FINAL ENVIRONMENTAL IMPACT REPORT

Amargosa Creek Improvement Project

SCH No. 90010820

AUGUST 1993

Exhibit 3.0-3A

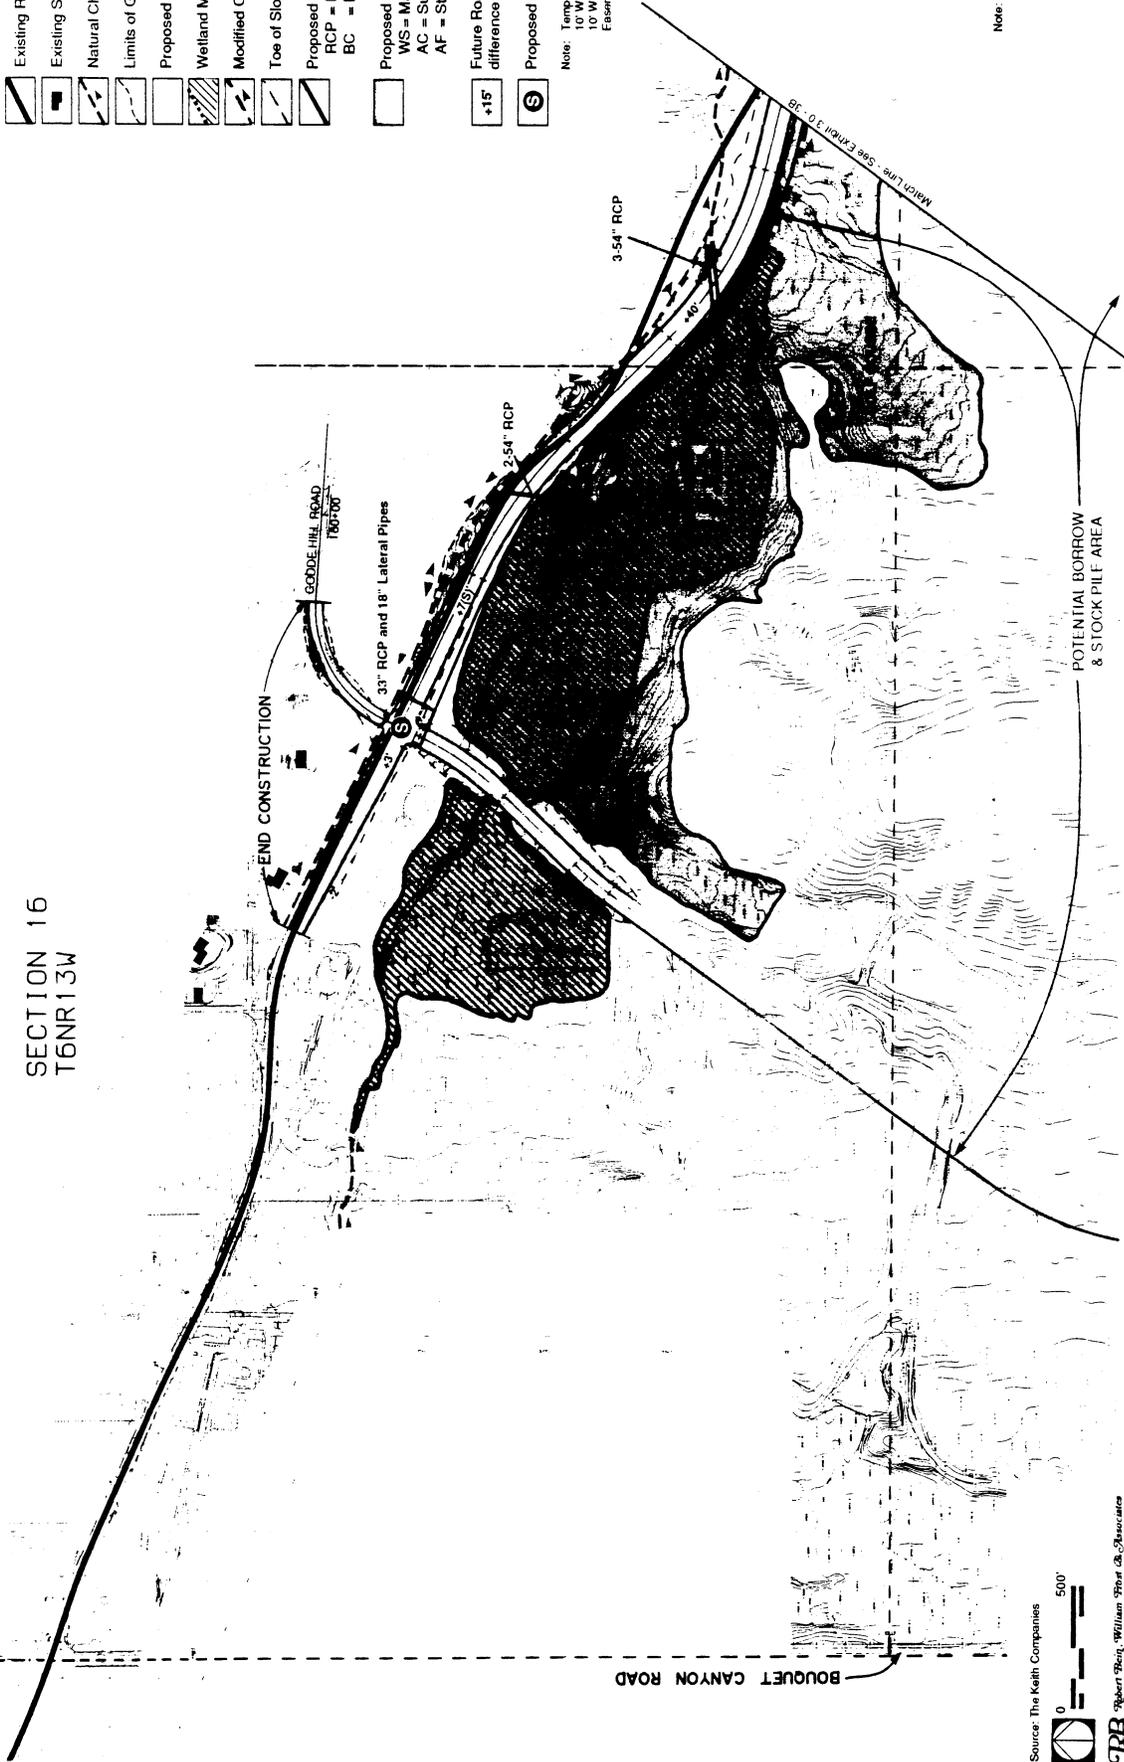
2.) Exhibit 3.0-3A shows a significantly larger wetland mitigation area than that which is depicted on AD90-1 Basin B grading plans. Much of the area shown on this exhibit will be in conflict with golf course plans.

Exhibit 3.0-3A depicts the proposed wetland mitigation area. The area is labeled as 124 acres. This exhibit is misleading in that the entire Basin B area is 124 acres. The wetland mitigation area only encompasses 57 acres of lost habitat and 37 acres of recreated wetland mitigation area. Exhibit 3.0 - 3A should be revised to reflect the accurate acreage of mitigation area.

- 3b. The cross-hatched area shown in Exhibit 3.0-3A is based on 1"=40' grading plans provided to RBF by The Keith Companies, dated April 24, 1991. The light blue area marked "Golf Course" was the only area shown for that land use type on the subject plans. Mitigation requirements for this project will be finalized as part of the ACOE 404 permit process, following design plan modifications in progress (see Response No. 14).

- 3f. The wetland mitigation area shown in Exhibit 3.0-3A is intended to be undisturbed, and therefore must have restricted access either through fencing or signage. This does not preclude use of integrated wetlands with the golf course area, which is a separate issue related to planning and mitigation for the Ritter Ranch project.

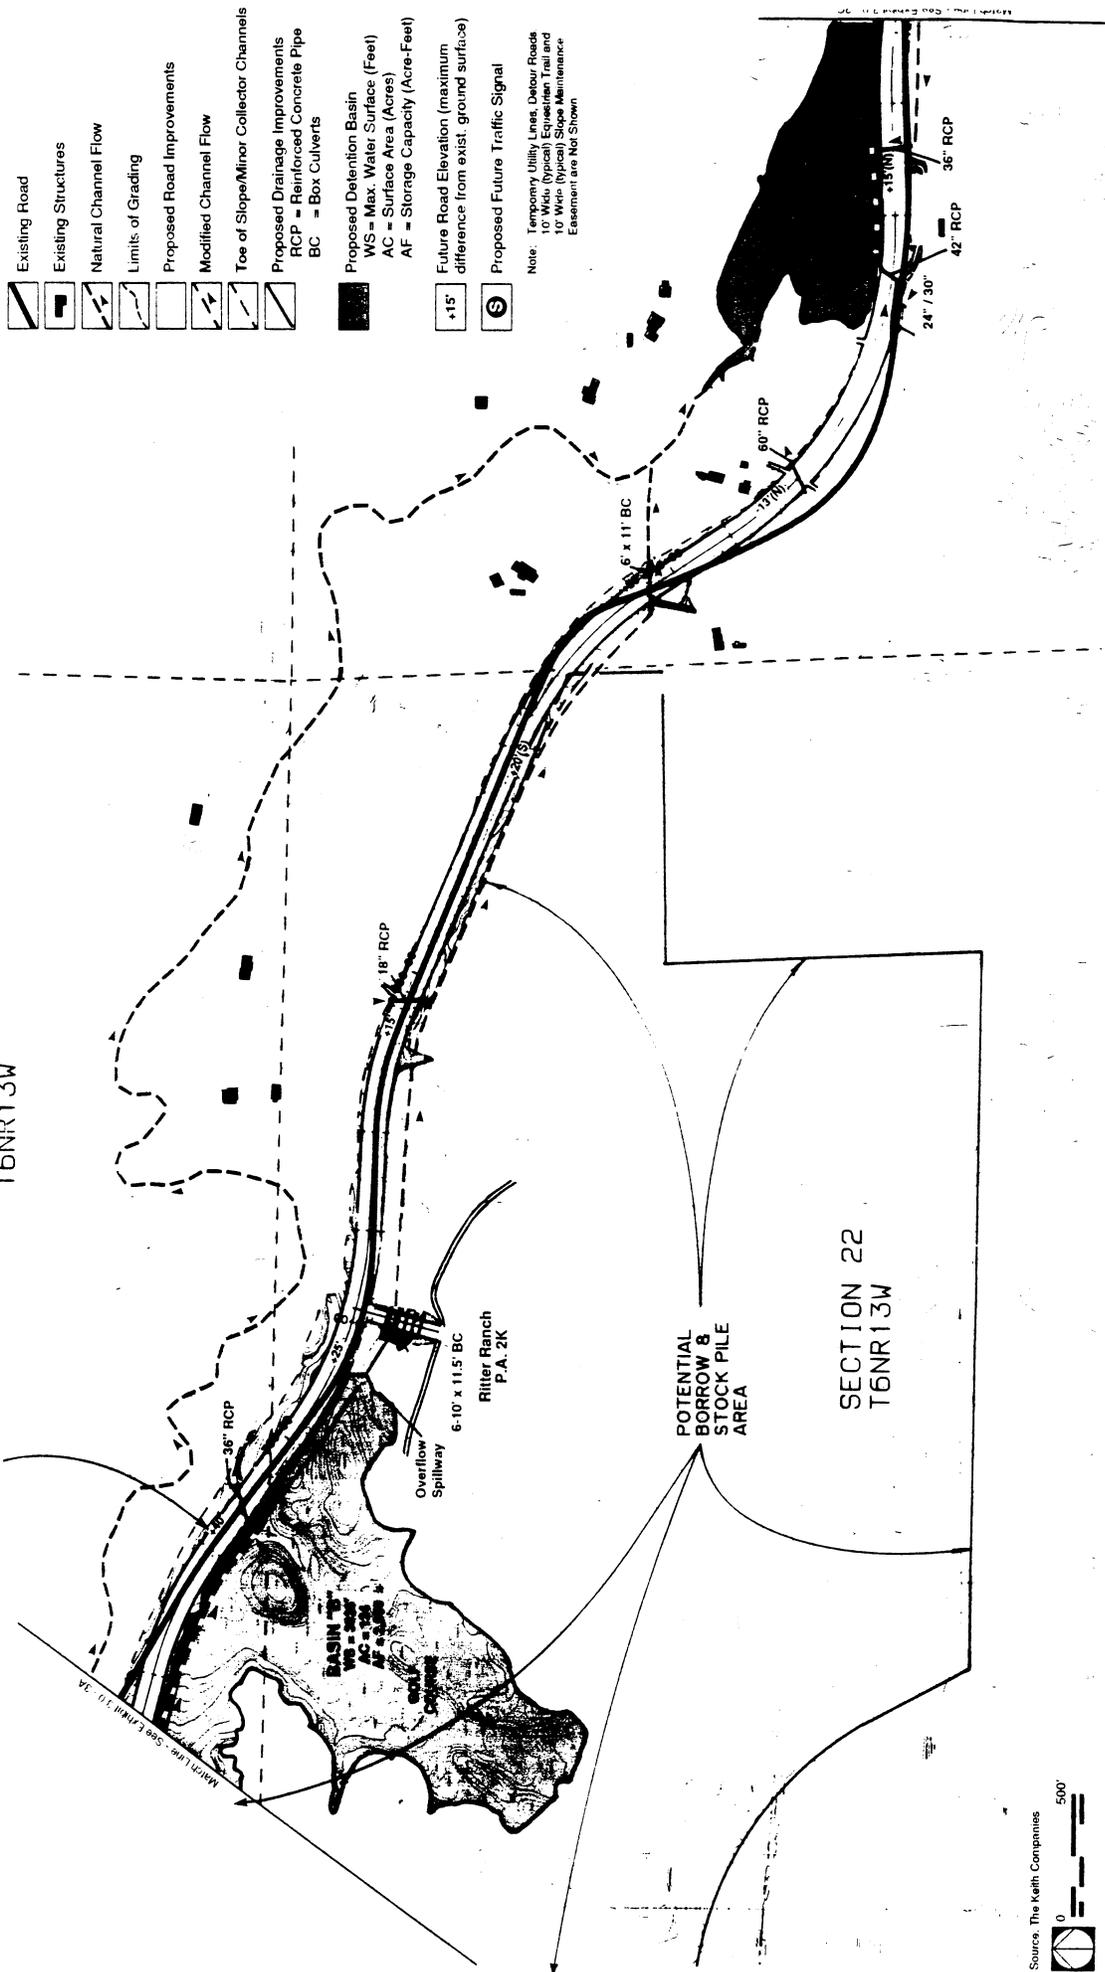
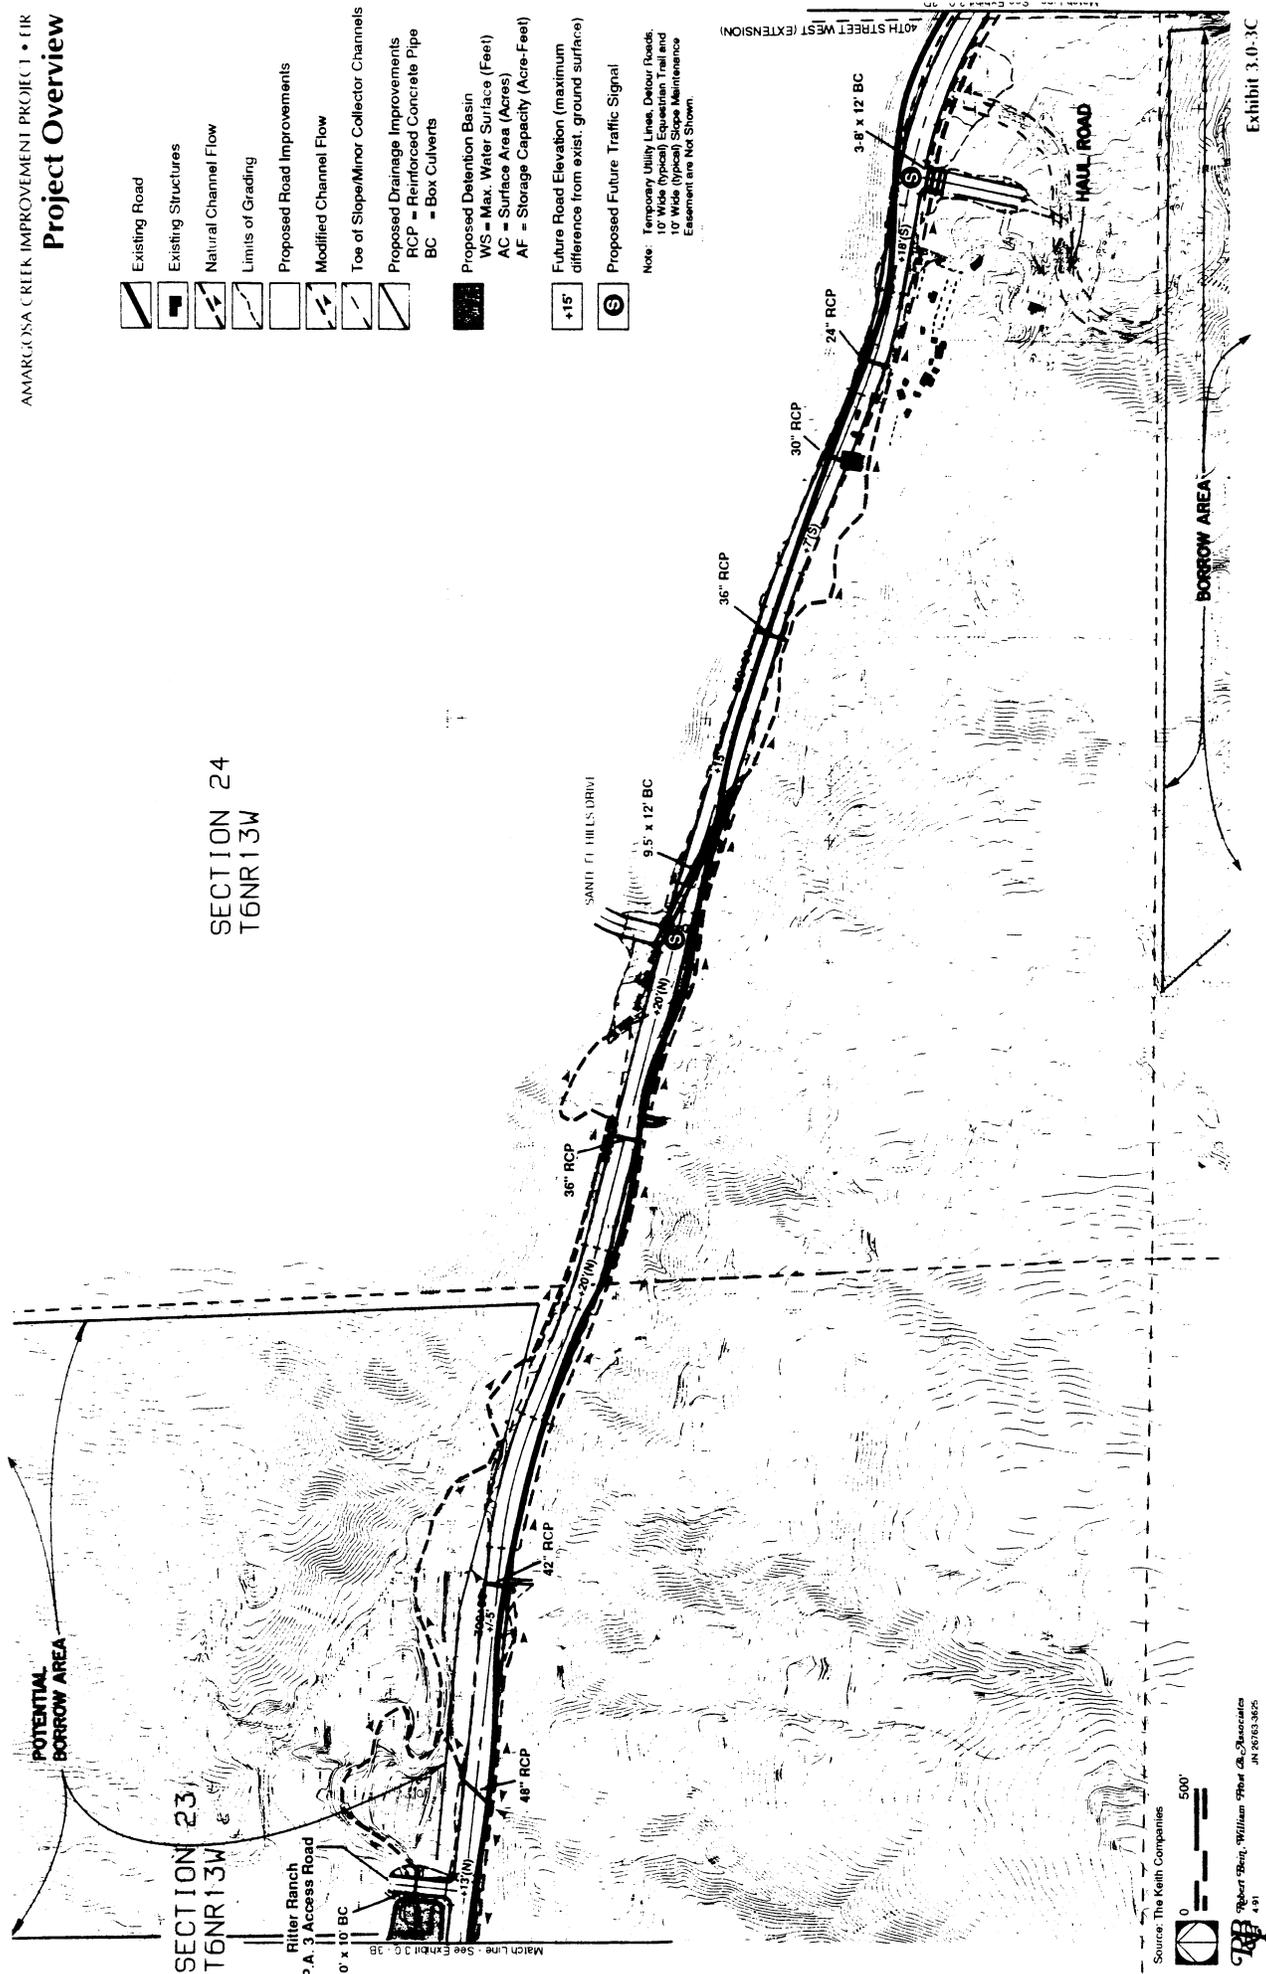
3.) Exhibit 3.0-3B does not show the 54" storm drain along E.L.R. (See Culvert Table for corrections regarding culvert sizes.)

- 3c. Exhibit 3.0-3B does not show all facilities. The Draft EIR was based on culvert data provided in Appendix I, ASSESSMENT DISTRICT REPORTS (see Response no. 3i).
